Questions & Answers

ITB 23-16 CR83A BEAR CREEK BRIDGE REPLACEMENT

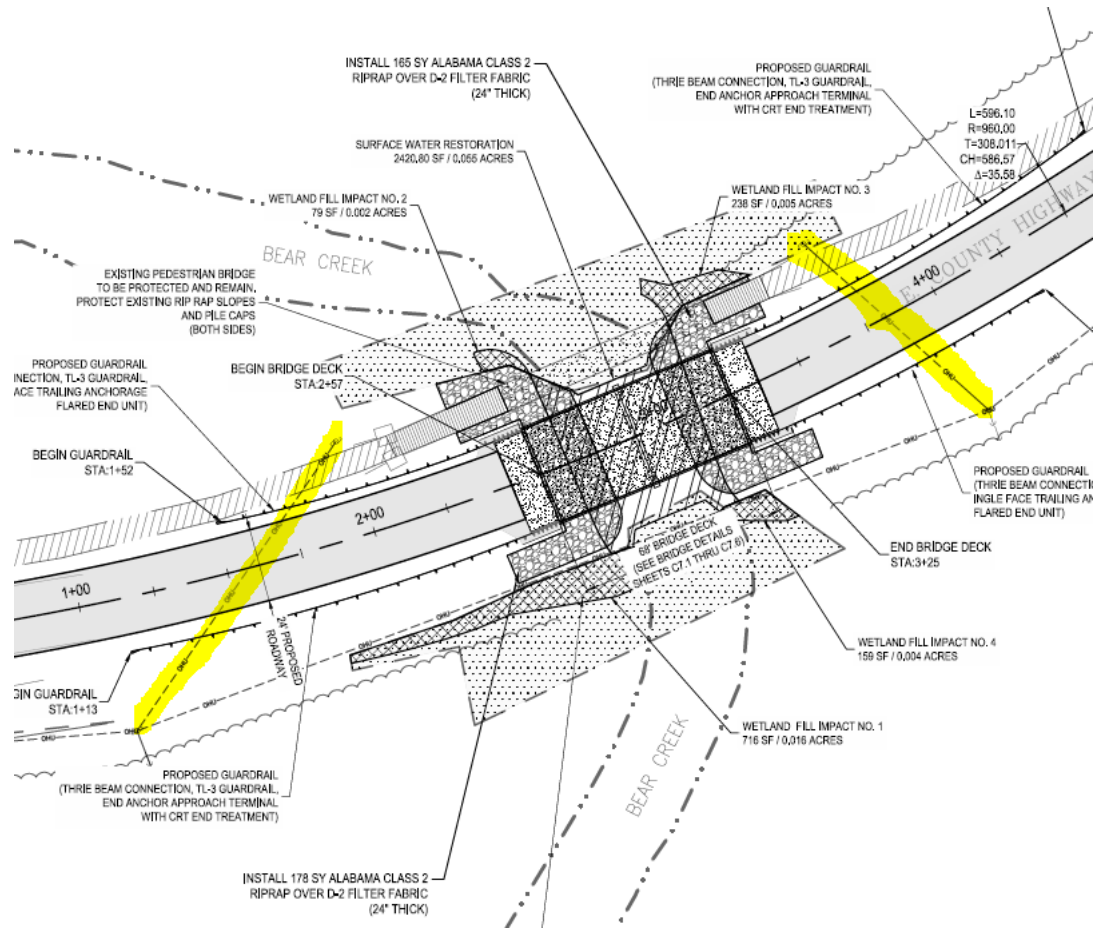
9. Can the county have the overhead lines which cross the street to existing light poles removed during the project? Highlighted below.

Response: Walton County will coordinate with Chelco to remove the lines prior to construction and to replace the lines after all crane work has been completed. The removal and replacement of the lines will not be the responsibility of the contractor.
